Access Compliance Report Public Rights-of-Way (Pedestrian Signals)

Main Street: **N_ORANGE_OLIVE_RD** Cross Street: **LINCOLN_AVE** Location: **NE**

ADA ID: **SGAT210924141111** Signal Type: **One Push Button-Non APS** Overall Compliance: **No** Severity Scores: **BTN 1: 35** **BTN 2: N/A** **No BTN: N/A**

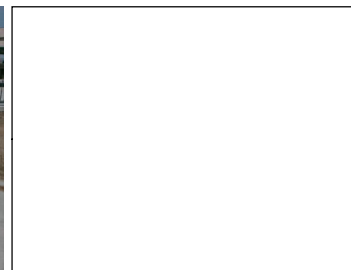
OC Std/PROW: MUTCD 4e.08, R404.2, R404.3

Possible Solutions: Replace Signal Push Button With APS Button. Remove & Relocate Sign.
